September 10, 2026

**Subject: ITB 27003-B: Solids Removal
Addendum #1**

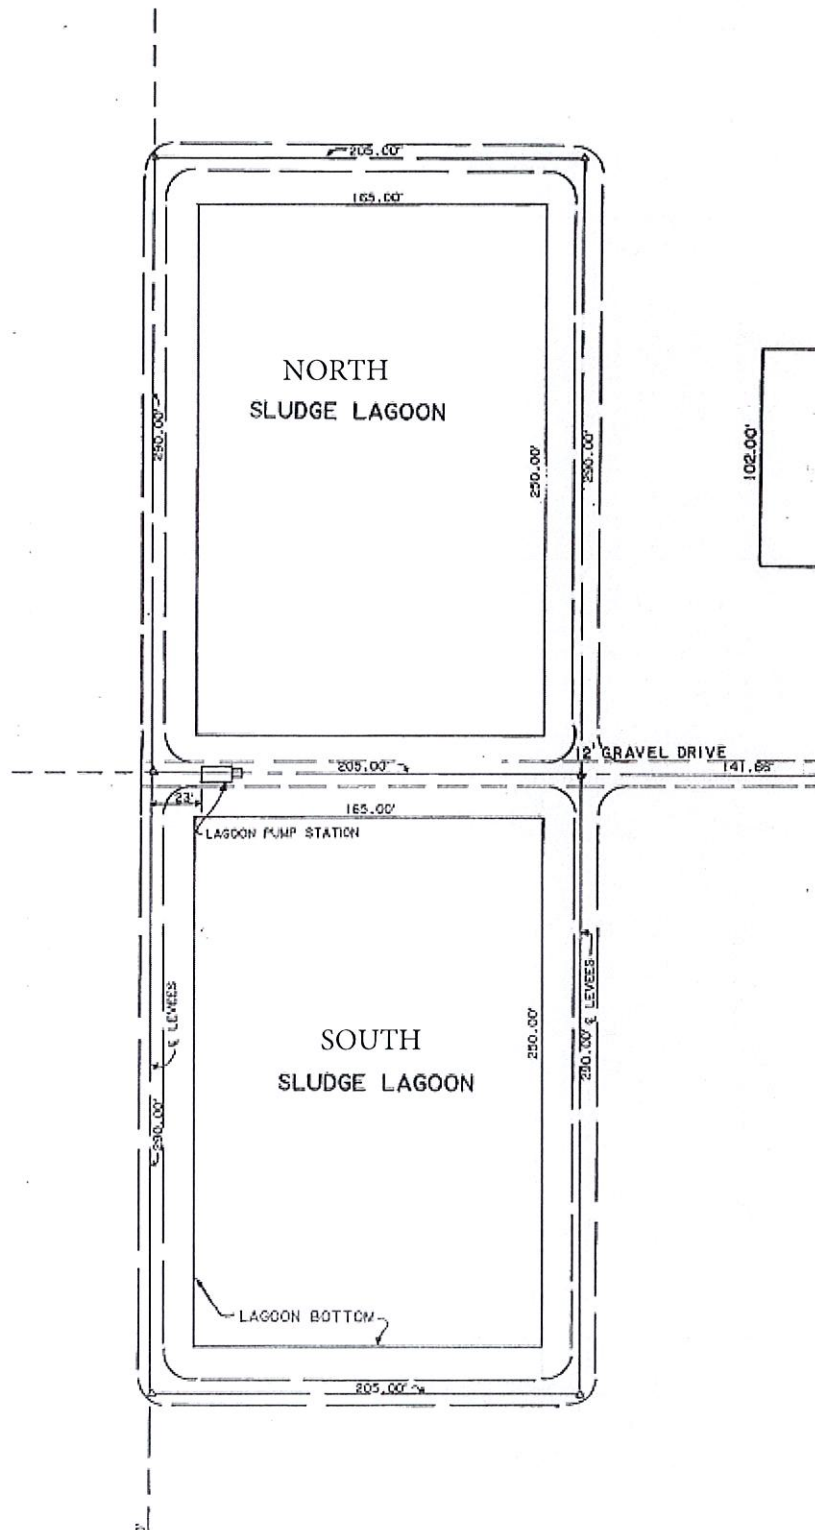
10. How deep are the North Lagoon and South Lagoon?

21. Is there a layout for each lagoon available?

Please see Attachments 1 & 2.

Please see Attachments 1 & 2.
